Addendum 02

DOCUMENT 00 91 00

DATE: January 29, 2026

PROJECT: Tipp City Seniors New Addition
528 North Hyatt Street
Tipp City, Ohio 45371

2 BULKHEAD DETAIL
1 1/2" = 1'-0"

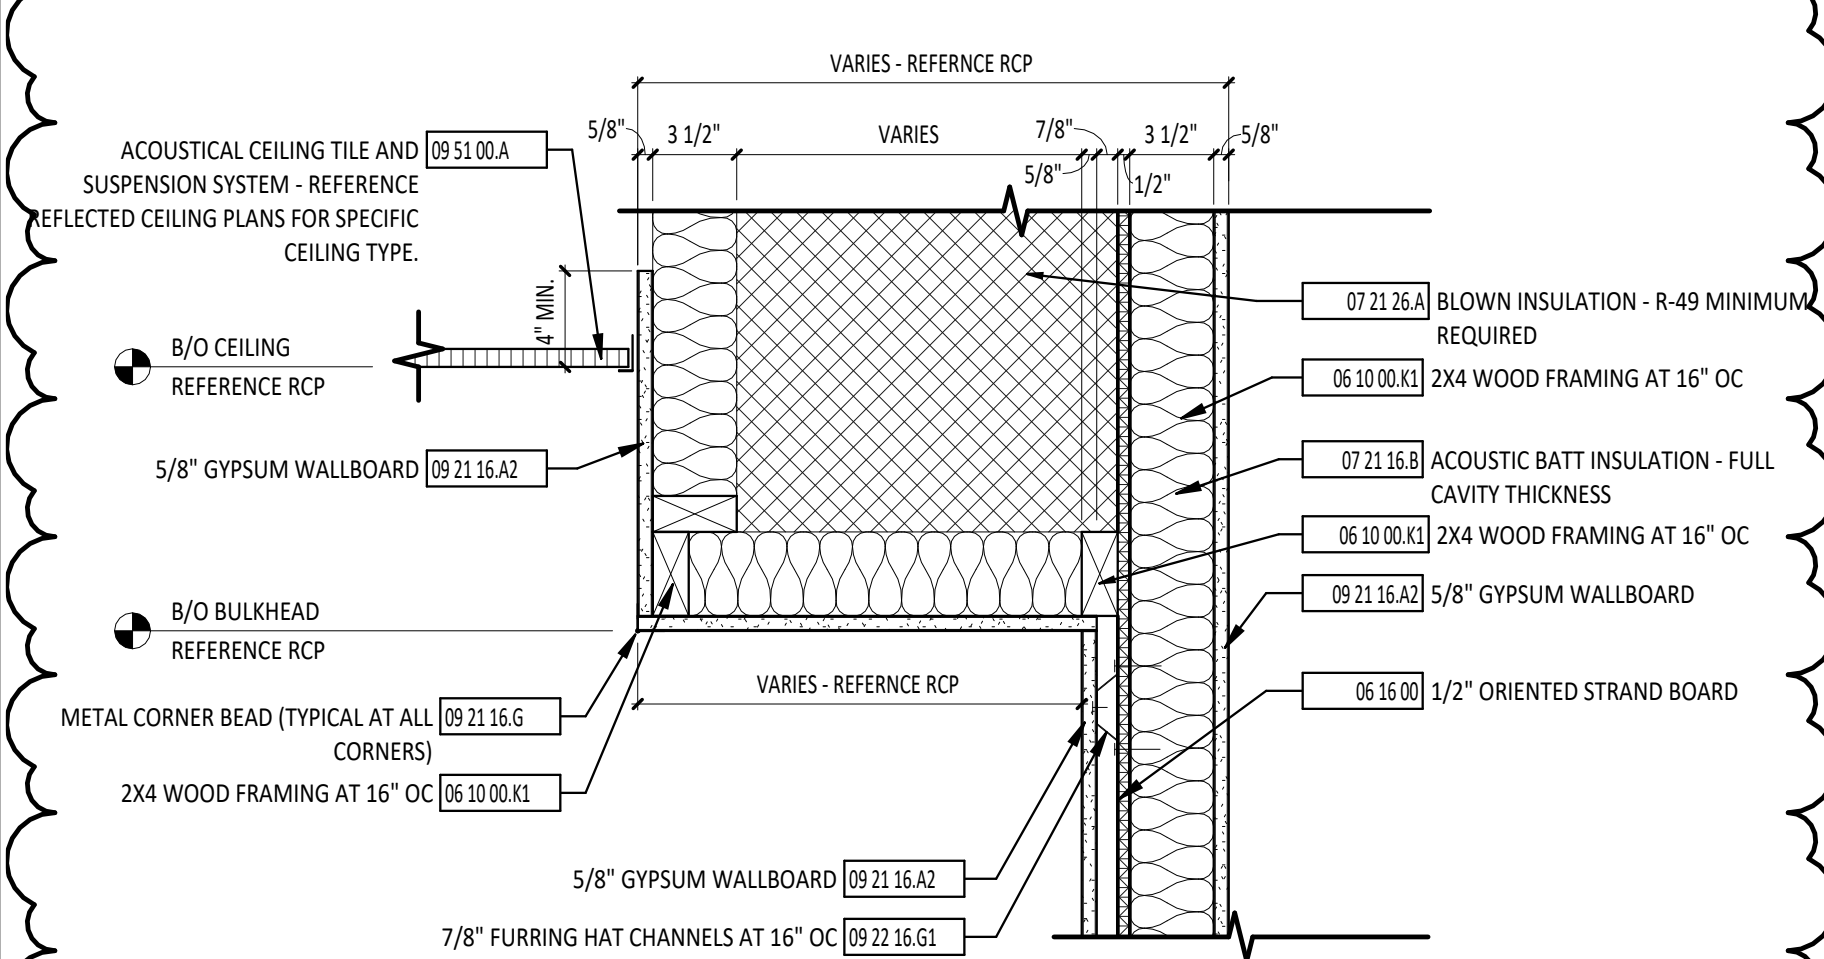
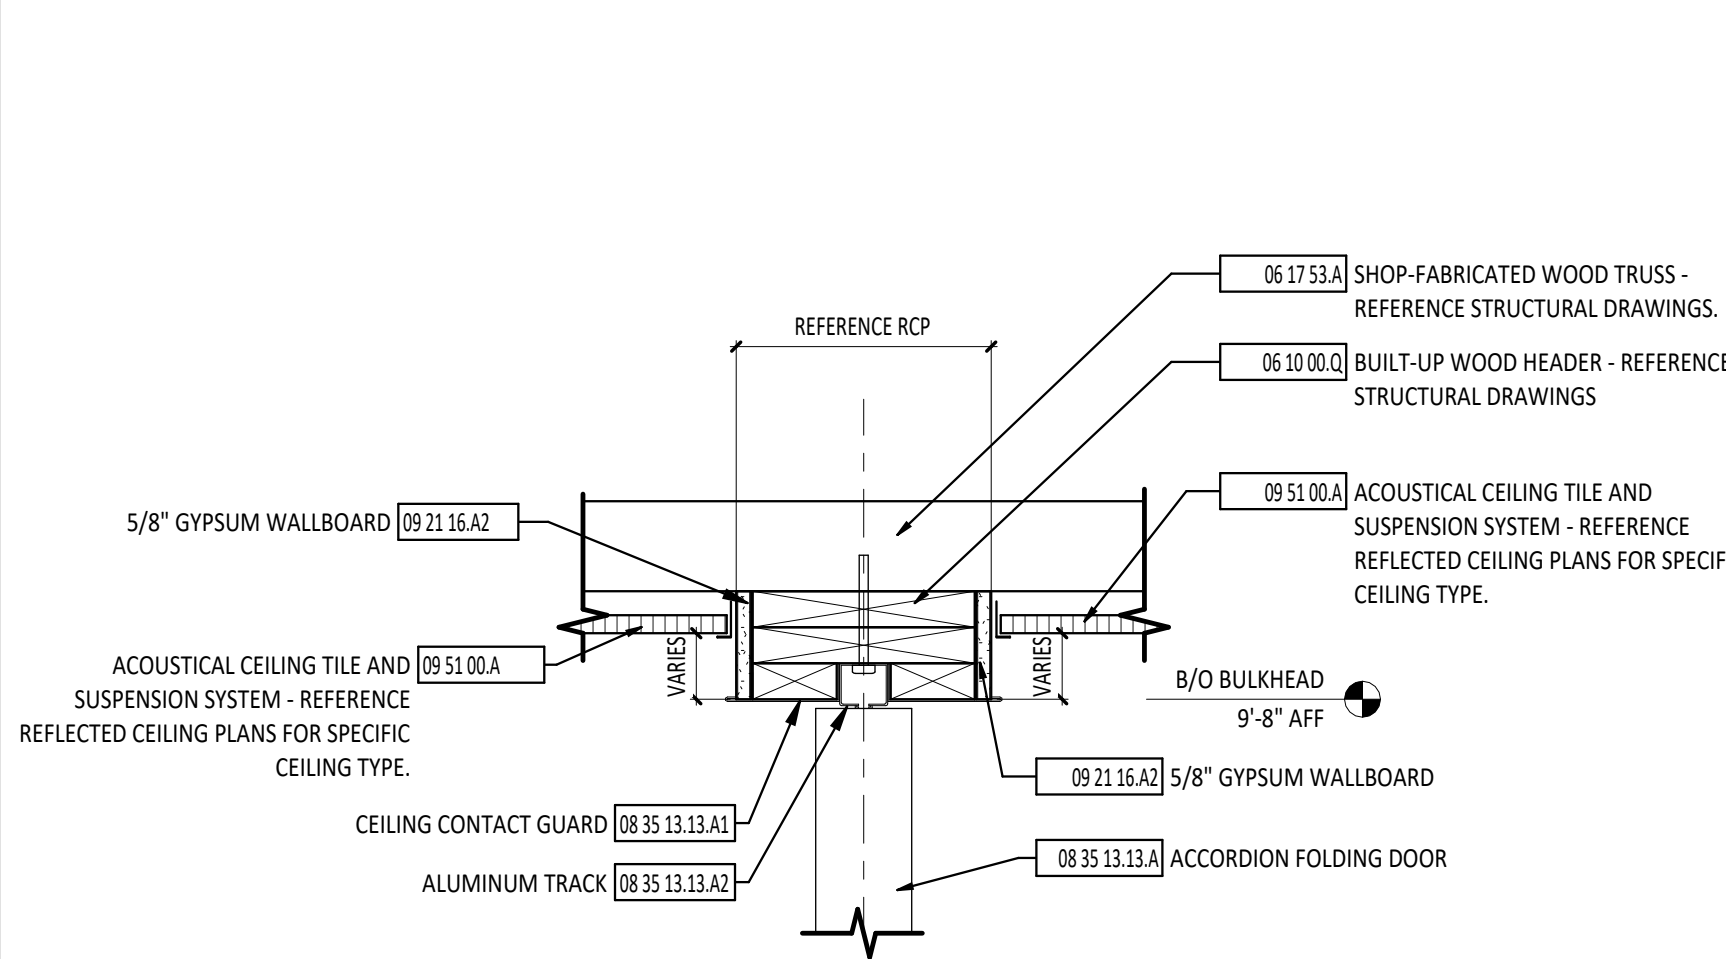
4. Drawing Sheet A7.1 Reflected Ceiling Plan – Unit A:
 - a. Added blown insulation to bulkhead details 2/A7.1 and 3/A7.1
5. Drawing Sheet M2.1 First Floor Mechanical Plan – Unit A:

1 FIRST FLOOR SYSTEMS PLAN - UNIT A
1/8" = 1'-0"

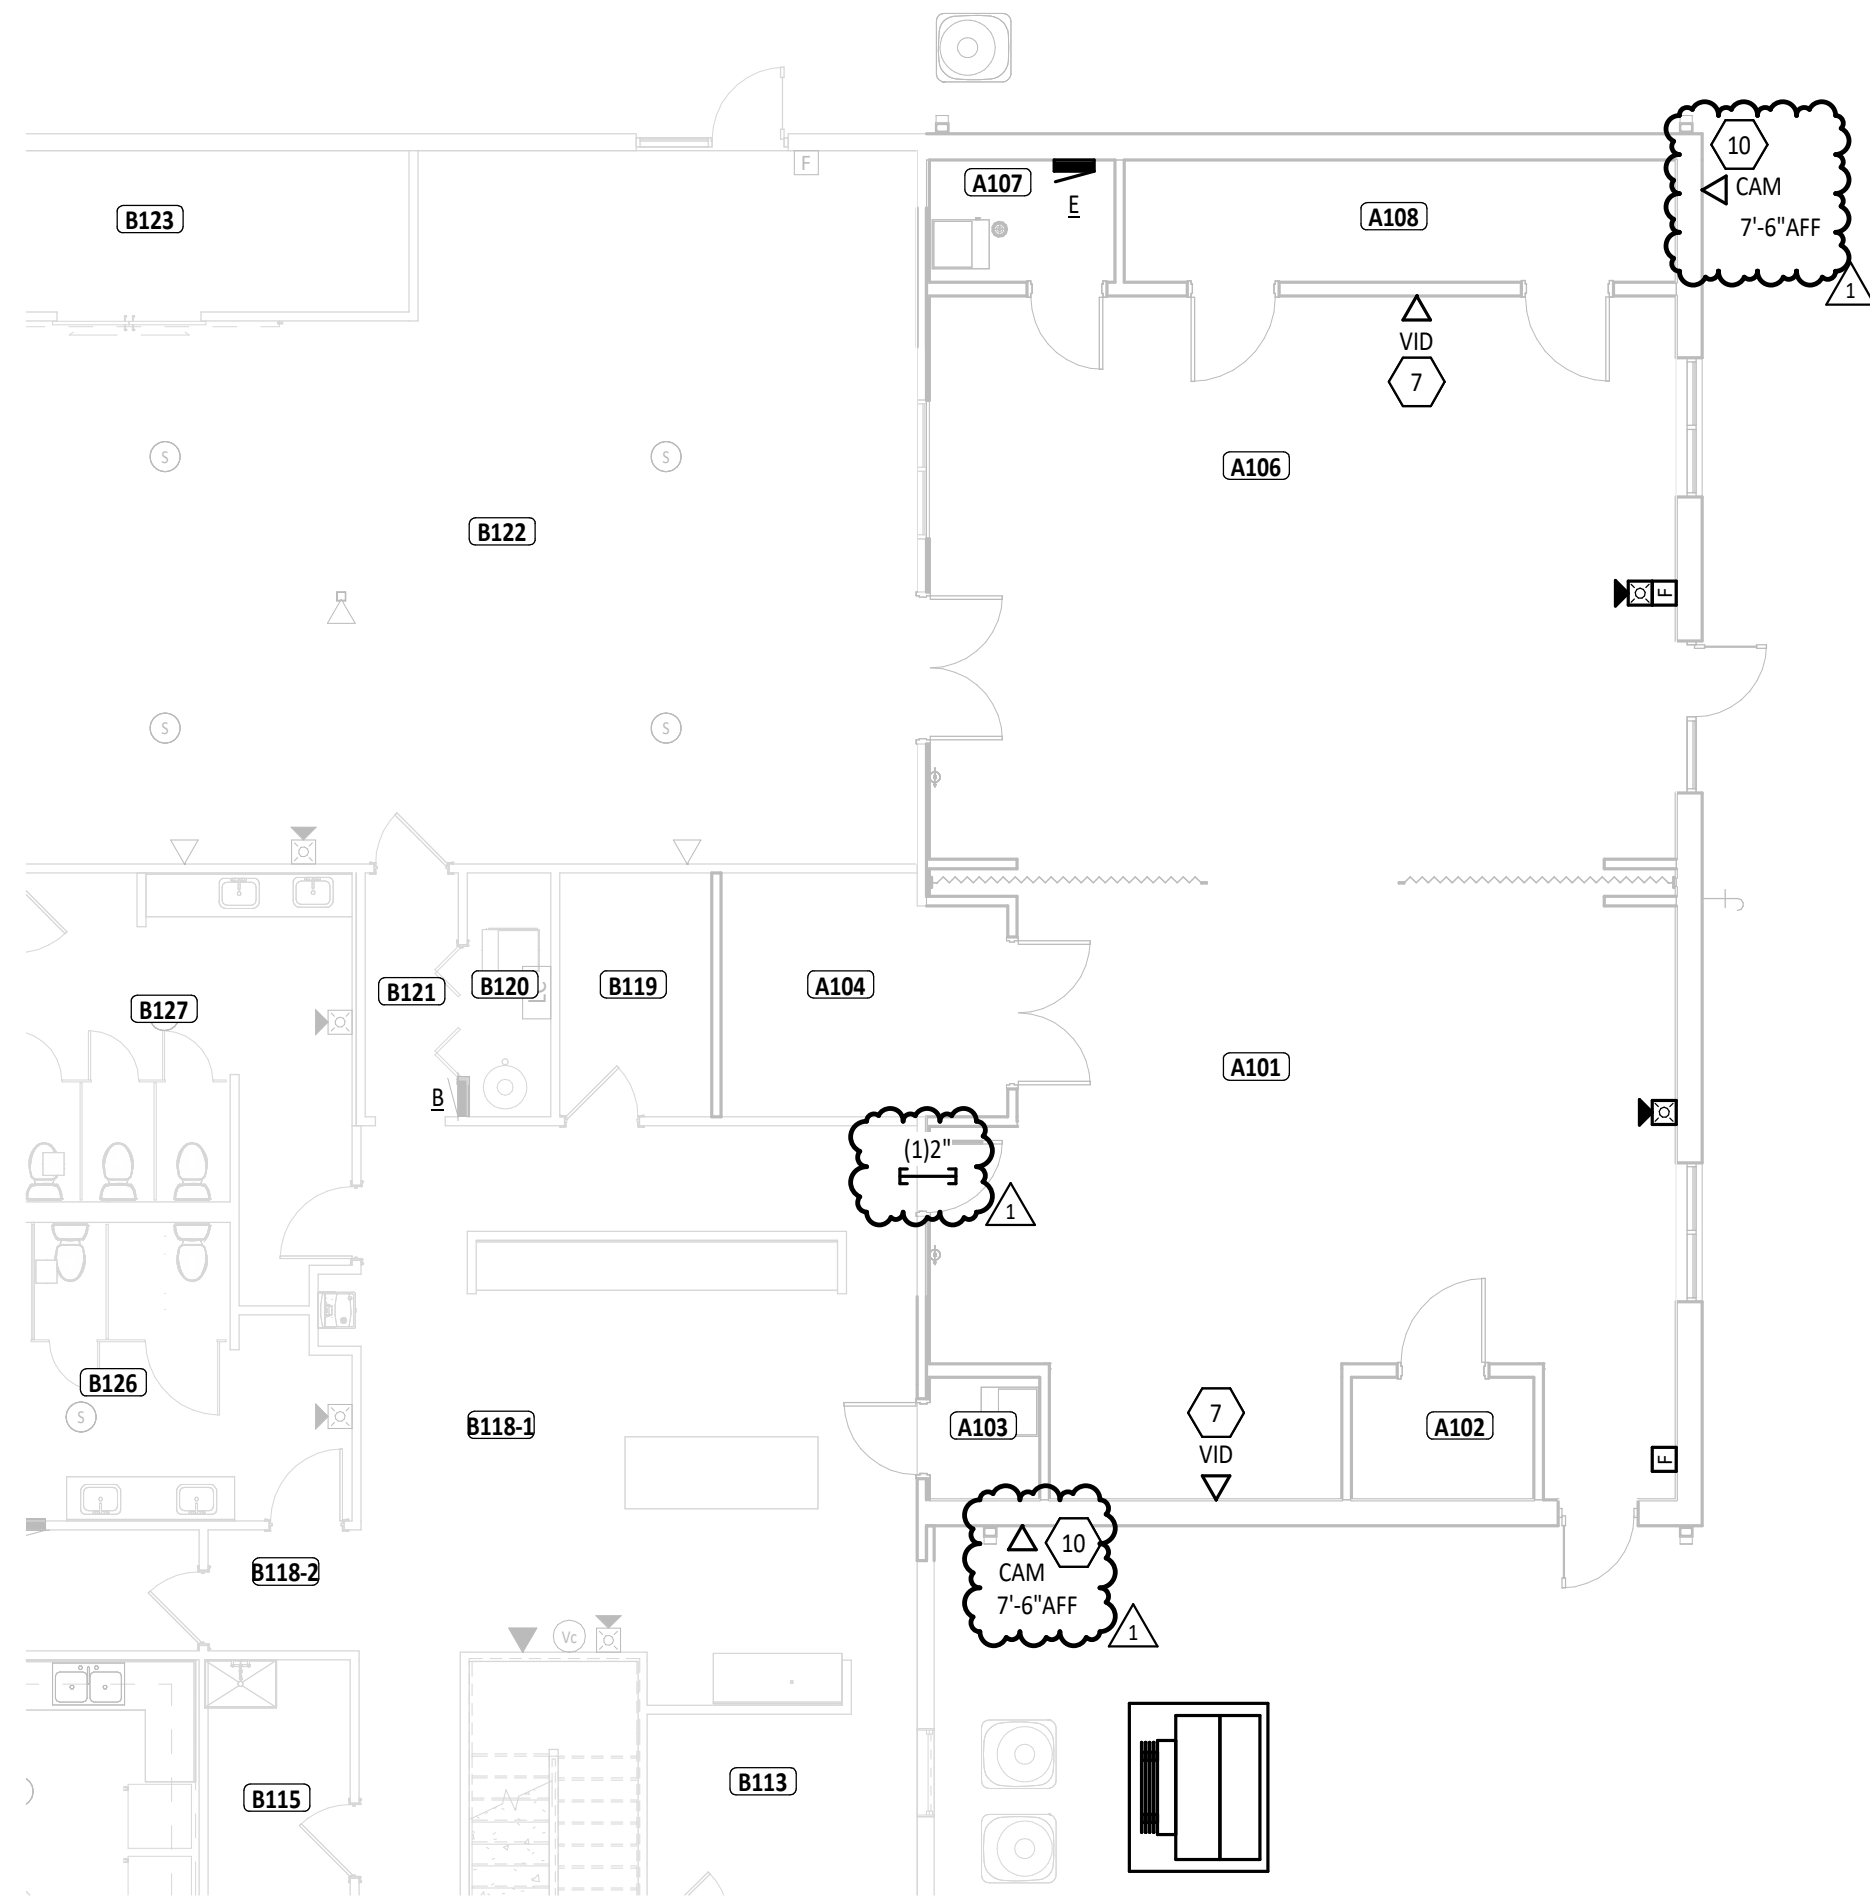
7. Drawing Sheet E3.1 Detail 1 First Floor Systems Plans – Unit A:
 - a. Add two rough-ins for exterior security cameras.
 - b. Add one, two inch conduit sleeve into new addition for technology cabling.

9	PROVIDE JUNCTION BOX FLUSH IN WALL WITH BLANK COVERPLATE FOR FUTURE 208V WOODWORKING EQUIPMENT. PROVIDE (1) 2" CONDUIT FROM PANEL 'E'.
10	PROVIDE SINGLE GANG, FLUSH MOUNTED JUNCTION BOX ON EXTERIOR OF BUILDING WITH 1" CONDUIT STUBBED TO INSIDE. MOUNT THE BOX AND CABLE SLEEVE ABOVE THE CEILING FOR EXTERIOR CAMERA. PROVIDE PLASTIC BUSHING ON END OF CONDUIT AND WEATHERPROOF BLANK COVER FOR EXTERIOR BOX. COORDINATE WORK WITH TECHNOLOGY CONTRACTOR PRIOR TO ROUGH-IN.
